UNITED STATES
NUCLEAR REGULATORY COMMISSION
OFFICE OF NUCLEAR REACTOR REGULATION
WASHINGTON, D.C. 20555-0001

NRC INFORMATION NOTICE 96-50: PROBLEMS WITH LEVERING-IN DEVICES IN
WESTINGHOUSE CIRCUIT BREAKERS

Subject DHP BREAKERS: LEVERING-IN DEVICE		Number ESBU-TB- 96-05-R0
System(s) BALANCE OF PLANT SWITCHGEAR USING TYPE DHP MAGNETIC AIR CIRCUIT BREAKERS		Date 06/19/96
Affected Plants CAE, CBE, CCE, CDE, GCLN1, BDAV1, CSTL1, CSTL2, CYW, ANG, GHAT1, GHAT2, KPR, B3M11, GSUS1, GSUS2, KRK, SCE, GCH1, GCH2, GWNP2		S.O.(s)
References Westinghouse Instruction Books I.B. 32-253-2 and I.B. 32-253-4A & 4B, "Instructions for Procel-line Type DHP Magnetic Air Circuit Breakers"	Affects Safety Yes <input checked="" type="checkbox"/> Related Equipment No <input type="checkbox"/>	Sheet 1 of 7

Figure 1. Levering-In Device Prior 1982

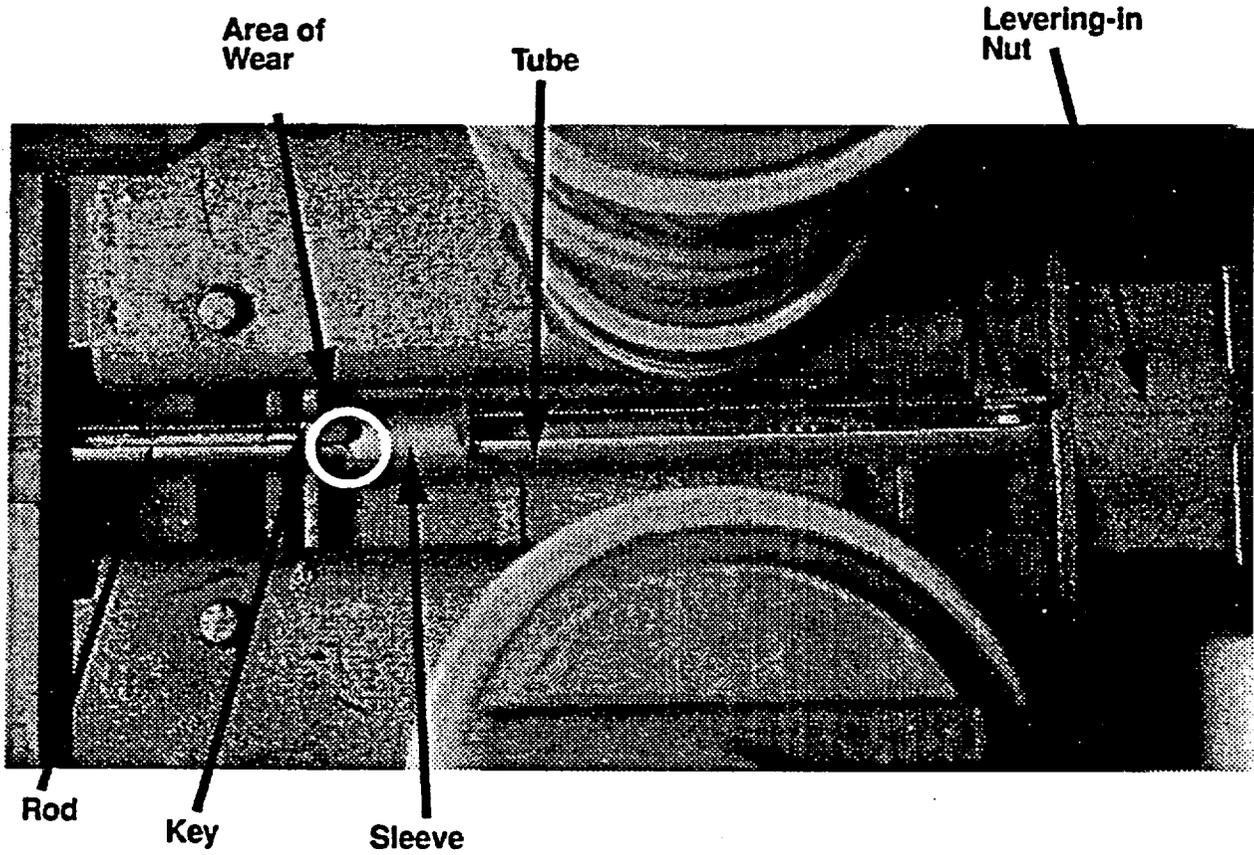
Westinghouse redesigned the levering-in device in 1982 to extend its service life. Figures 1 and 2 in the attached Westinghouse bulletin show the original and redesigned device installed in the breaker. Figure 6 is a sketch illustrating the difference in the guide tubes and levering shafts of the two designs. Interface between licensees and vendors in accordance with Generic Letter 83-28, "Required Actions Based on Generic Implications of Salem ATWS Events," issued July 8, 1983, can help ensure that information on safety-related components is complete and up to date.

The spin free of the crank could occur prematurely if the levering-in device is worn at the mating pieces of the shaft and tube. Refer to Figures 1 & 2 for the two versions of the levering-in devices and the area of wear. The earlier version has a key welded in one side of the shaft and the later version has a pin through the shaft that protrudes on both sides. The key/pin interfaces with the slot in the tube and as the crank is turned the key/pin travels along this slot to the end of the tube. At the end of the tube the key/pin reaches the tapered part of the sleeve on the tube and no longer engages with the slot and the crank becomes spin free stopping travel of the breaker. When this area at the end of the tube and the key/pin become worn, the crank can go spin free before the breaker has traveled all the way to the proper OPERATE/ENGAGED position.

- **The tube and shaft are free of cracks**
- **The pin or key and the mating area of the tapered part of the sleeve on the end of the tube are not worn**
- **The levering-in nut (refer to Figure 4) has a coating of Molykote BR2 Plus grease (Westinghouse P/N 53701QB12J)**
- **The threads on the levering-in nut and screw should be checked with go/no-go thread gages**
- **Additionally, the floor trippers should be checked to insure that they are not bent.**

Figure 5 - Schematic of Levering-in Device and Interlock

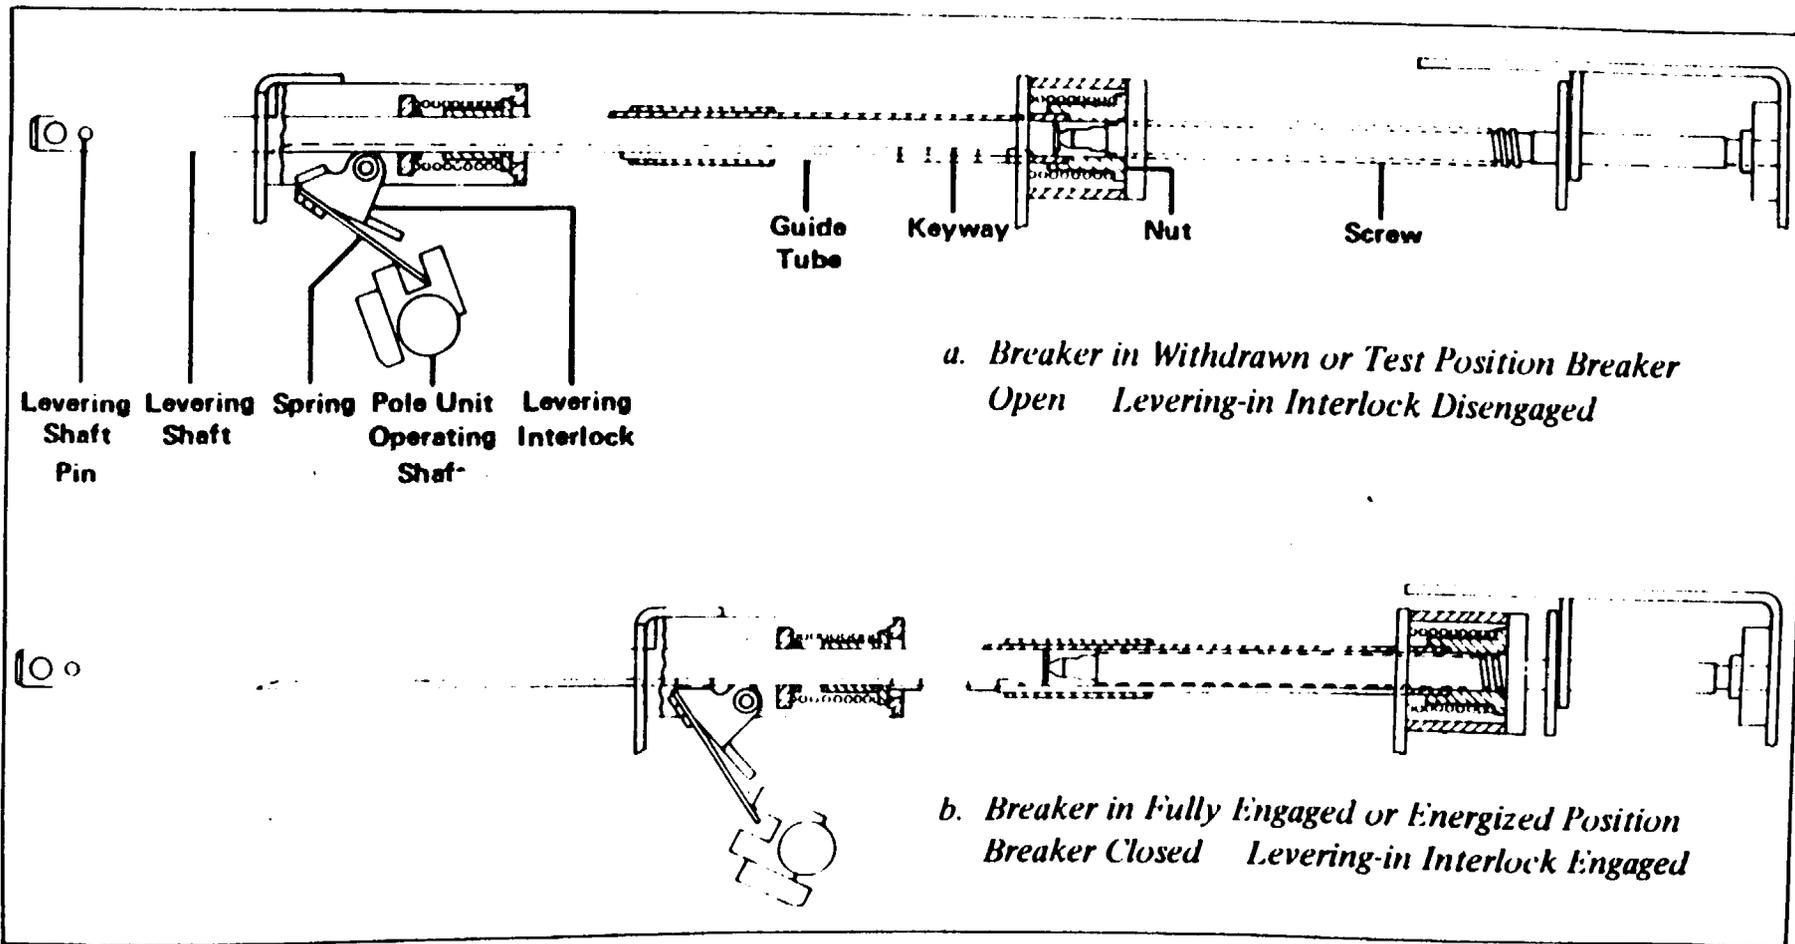
When installing a Model DHP breaker, a plant equipment operator first pushes it into a cell in the switchgear until the rail latch catches and stops further movement toward the rear of the cell. At this point the breaker is in the TEST position and the levering-in device is not yet engaged. By pressing down on the rail latch, the operator can push the breaker another small increment until the levering nut at the rear of the breaker contacts the levering screw in the cell. The operator then attaches a manual crank to the levering shaft at the front of the breaker and turns the crank. Turning the crank causes the levering nut to traverse the levering screw, drawing the breaker into the cell until the breaker stops moving toward the rear of the cell and the crank and levering shaft spin free, indicating that the breaker is fully engaged. Figure 5 is a schematic diagram of the levering-in device.

If the levering-in device is worn, the operator receives an erroneous indication that the breaker is fully engaged and ready to operate, when in fact the floor tripping mechanism is still engaged. The floor tripping mechanism consists of cam plates on the cell floor that lift trip levers on the underside of the breaker while the breaker is being inserted or removed from the cell. With the floor tripping mechanism engaged, the breaker will not close onto the bus. The Braidwood licensee subsequently removed the defective levering-in device and replaced it with a redesigned levering-in device.

Figure 6 - Difference in Original and 1982 Redesigned Levering-in Devices

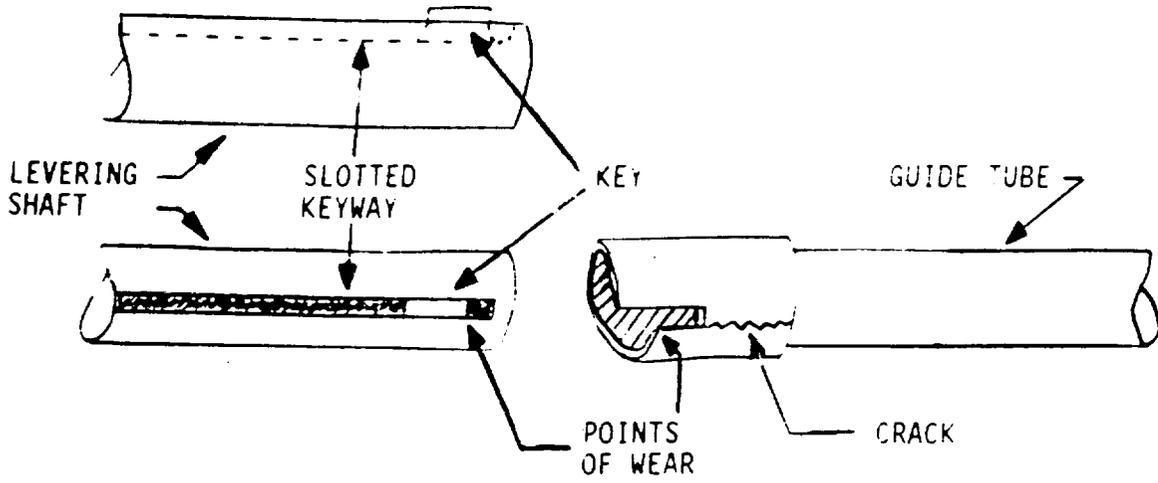
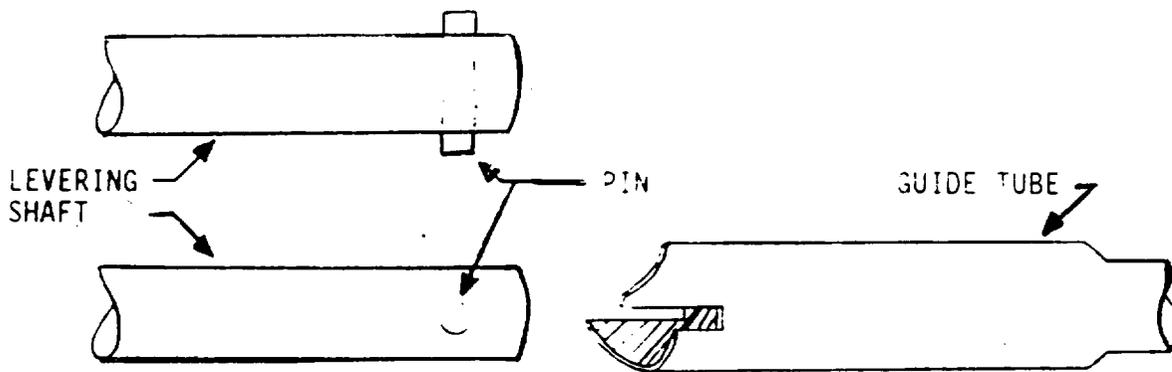
The root cause of the failure was a worn levering shaft key and a worn and cracked guide tube. The mating surfaces between the shaft key and the guide tube were worn and permitted the levering-in device to spin free while the breaker was still about a quarter inch from being fully engaged on the bus.
